SUNDRY NOTICES AND REPORTS ON WELLS
Do not use this form for proposals to drill or to re-enter an abandoned well. Use form 3160-3 (APD) for such proposals.

8. Well Name and No.
CB SE 5 32 FED COM 12H

As discussed during the on-site conducted 5/10/2018 with Paul Murphy at Culebra Bluff, we are requesting a second entrance to the well pad.

CHEVRON U.S.A. INC.
PROPOSED PAD & ACCESS ROAD
CB SE 5 32 FED COM NO. 12H WELL
SECTION 5, T24S-R29E
EDDY COUNTY, NEW MEXICO

WELL PLAT

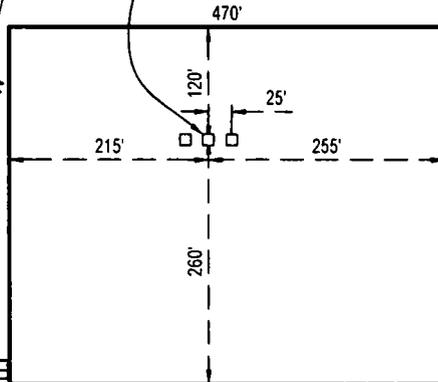
**** BLM REVISED ** BLM REVISED ** BLM REVISED ** BLM REVISED ** BLM REVISED ****

CENTERLINE
PROPOSED WEST
ACCESS ROAD
20' x ±145.45'
±8.82 Rods
±0.07 Acres

CENTERLINE
PROPOSED EAST
ACCESS ROAD
20' x ±194.98'
±11.82 Rods
±0.09 Acres
